**World Forum for Harmonization of Vehicle Regulations****Working Party on Pollution and Energy**

**Retrofit Emission Control devices (REC)****Draft new Regulation on uniform requirements for Retrofit Emission Control devices (REC) for heavy duty vehicles, agricultural and forestry tractors and non-road mobile machinery (NRMM) equipped with Compression Ignition engines.**

Draft Version 2.2 dated 28.10.2011

**Annex 3.****Arrangement of the REC type approval mark**Model A

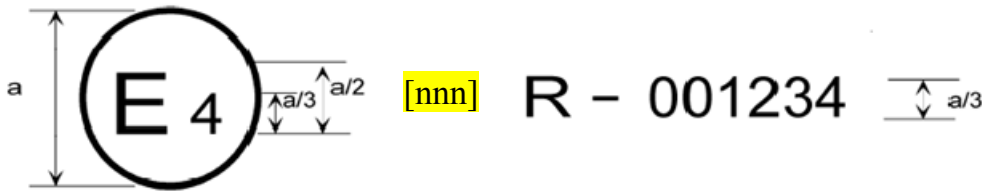
Comment [DB31]: Min measure big enough?
